ADDENDUM NO. 1 TO 20-0074-4

FOR: CHARLIE BROOKS PARK EXPANSION - PHASE 2				
PLEASE SEE THE FOLLOWING FOR ADDITIONS, CLARIFICATIONS AND/OR CHANGES:				
1. See attached REVISED Plan Sheets (5 sheets)				
IR-1 of IR-5				
IR-2 of IR-5				
IR-3 of IR-5				
IR-4 of IR-5				
IR-5 of IR-5				
2. See attached sheet (1 page) for Responses to Questions received and added suppliers.				
3. The Bid Opening date/time has been extended to 2pm, Tuesday, October 13, 2020.				
\$. Due to the bid opening extension, we will extend the receiving of additional question until 11am, October 6, 2020.				
BID OPENING HAS BEEN EXTENDED TO: 2PM, TUESDAY,				
OCTOBER 13, 2020

ADDENDUM NO. 1 - REVISED SEPTEMBER 2020 - REDUCED PUMP CAPACITY

# IRRIGATION PLAN CHARLIE BROOKS PARK - PHASE 2

SCALE NOT TO SCALE SHEET IR-5 OF IR-5

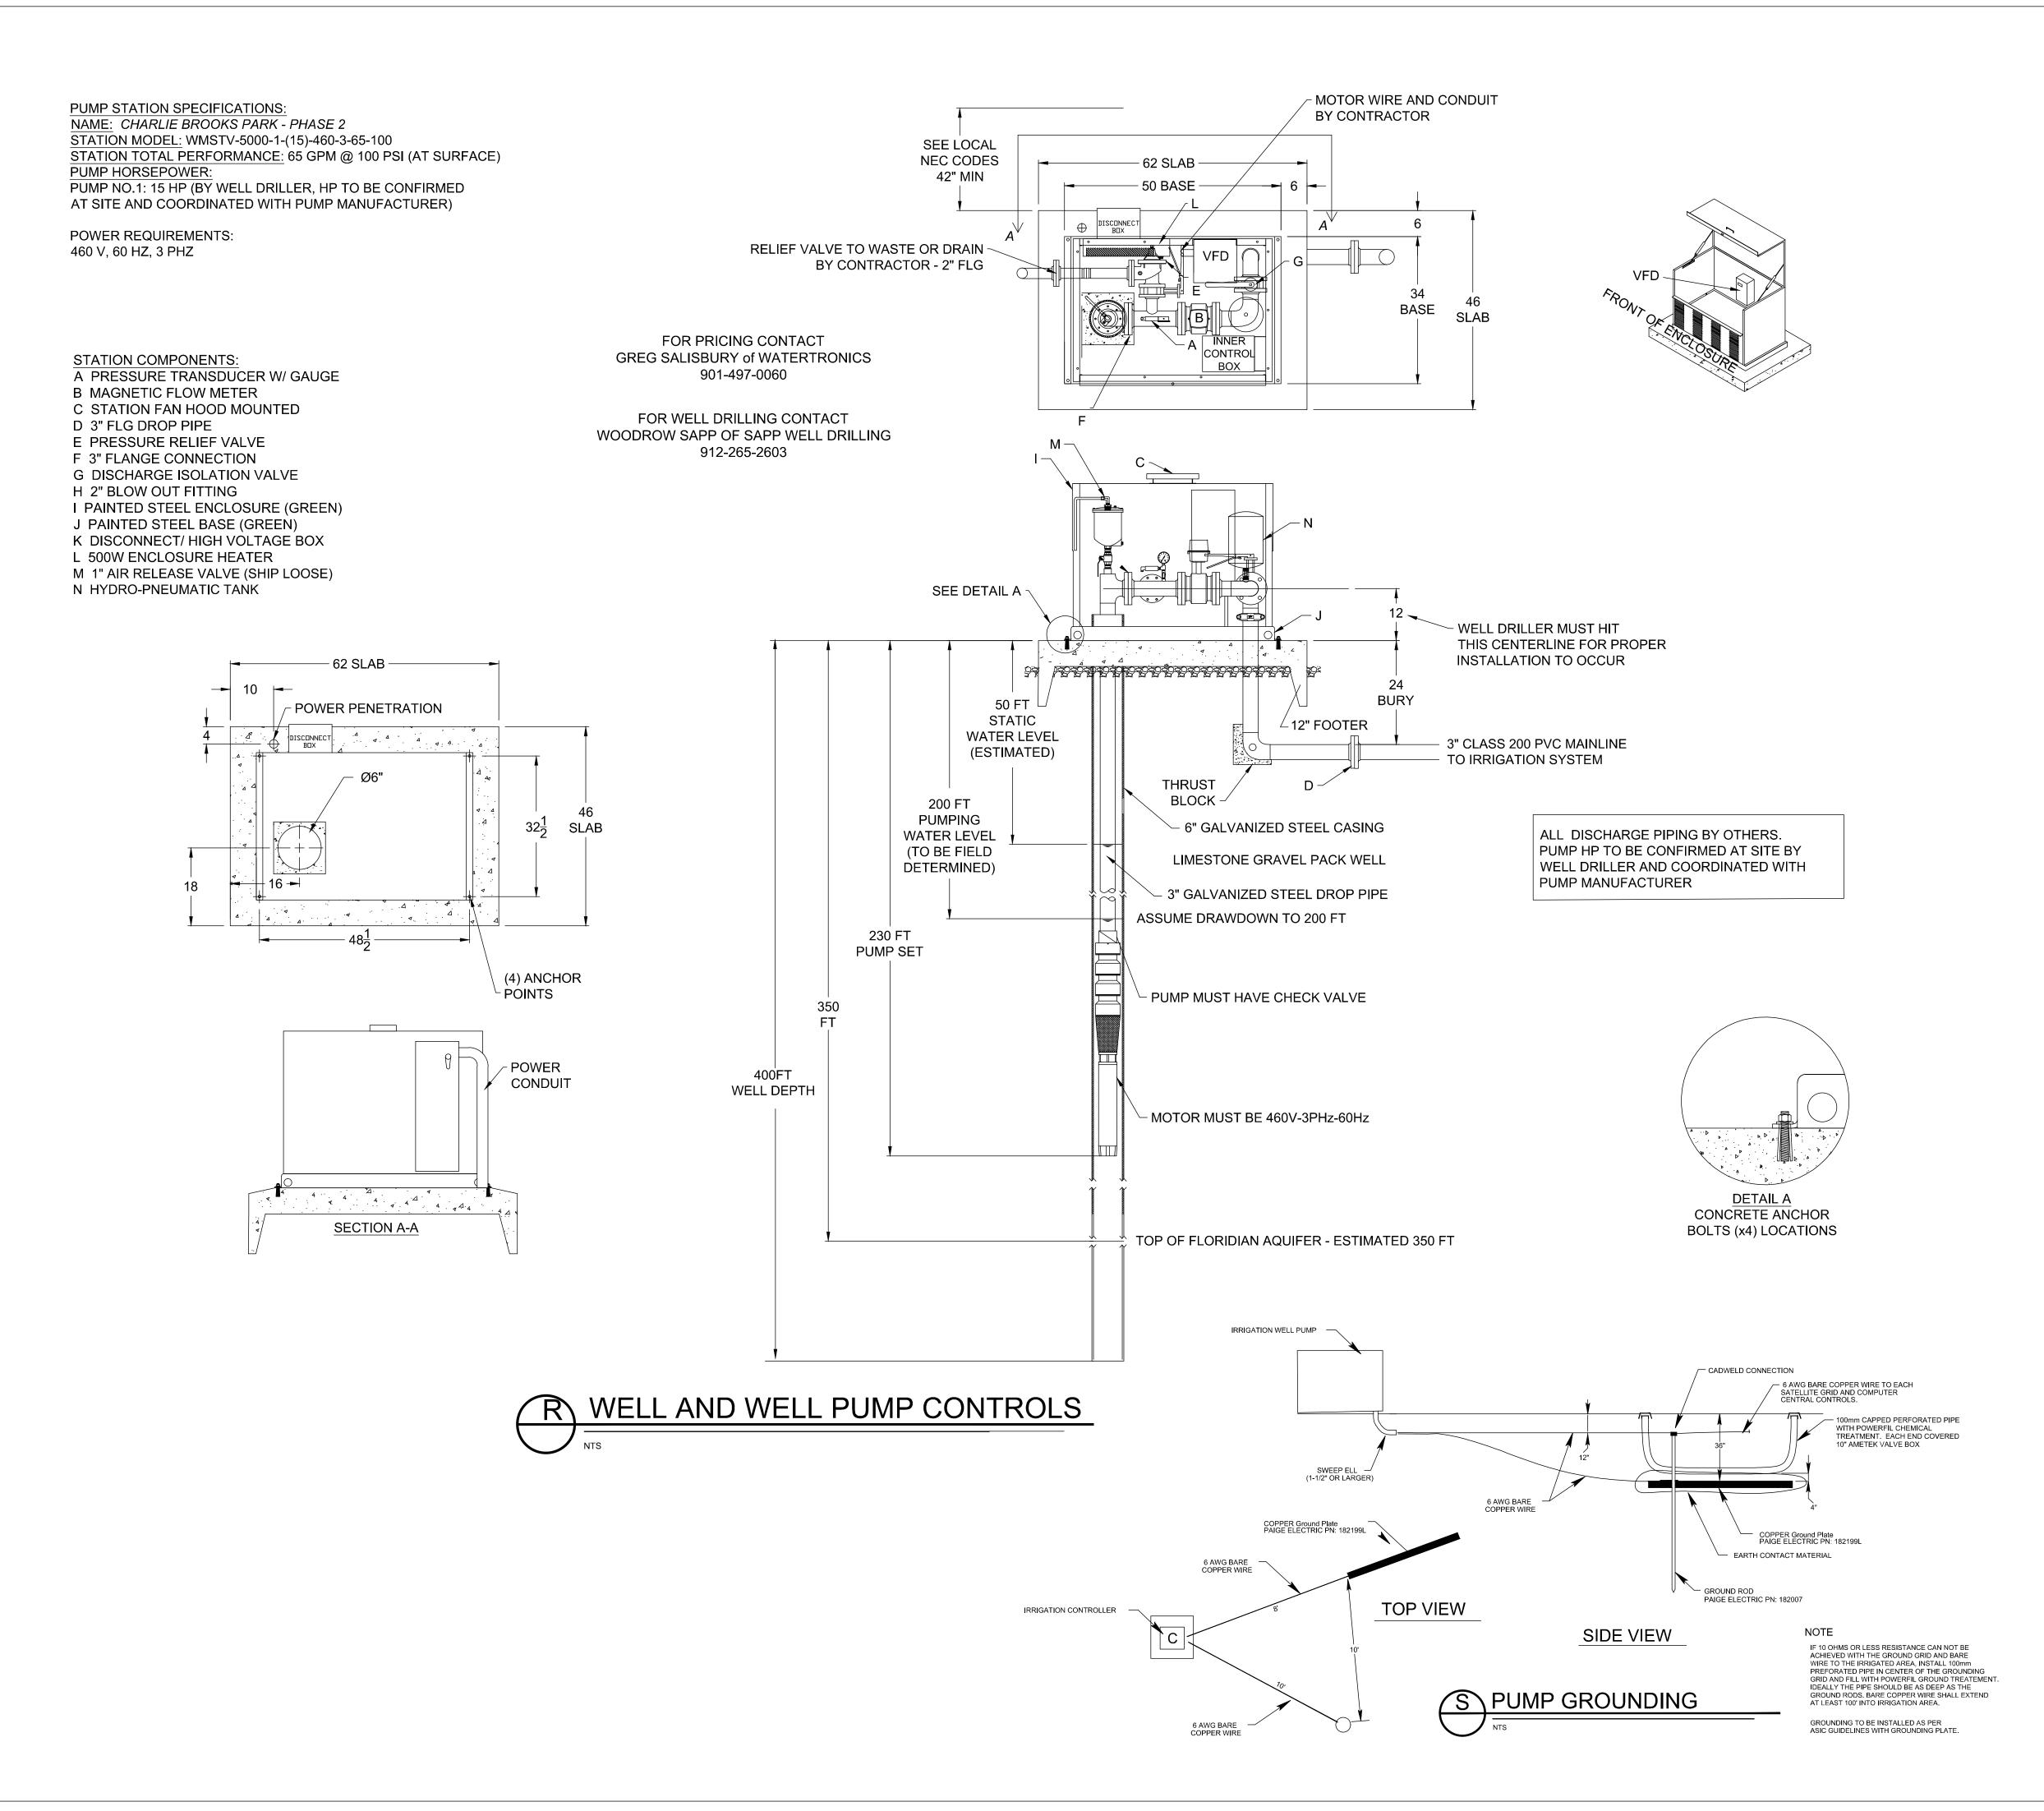
- 1.Q) If when drilling the well, the driller encounters land fill materials and is forced to move and start a new hole, who is responsible for costs incurred?

- 4. The proposed irrigation well shall not be installed through waste. If waste is encountered during drilling of the well, the installation will be terminated and abandoned. The well will then be relocated to an area where there is no waste present. The well shall not be relocated more than fifty feet without approval from the Georgia Environmental Protection

- 5. If waste is encountered during drilling and the installation is to be terminated and abandoned the bore hole shall be tremie grouted with a low psi bentonite grout mixture (Portland Type II cement, 5-10 percent bentonite powder, and water) to within ten feet of the ground surface; the upper ten feet shall be filled with hydrated bentonite chips up to the ground surface.

- A) If waste is present, it will be located at a fairly shallow depth. Explorations will be done at the well location prior to the beginning of drilling. If waste is encountered, then the well location will be adjusted to a place where it can be confirmed that there is no waste. The cost of the explorations should be included in the price of the well.

- 2. Q) Is the design intent with the well to have an open hole limestone well, or a gravel-packed sand well with well screens?
  - A) The intent is to have an open hole limestone well.

The well drilling contractor is responsible for producing (1) well and controls that will service the irrigation system for the Charlie Brooks Park project in Chatham County, Georgia. The well shall supply 65 gallons per minute with a well discharge of 100 psi.
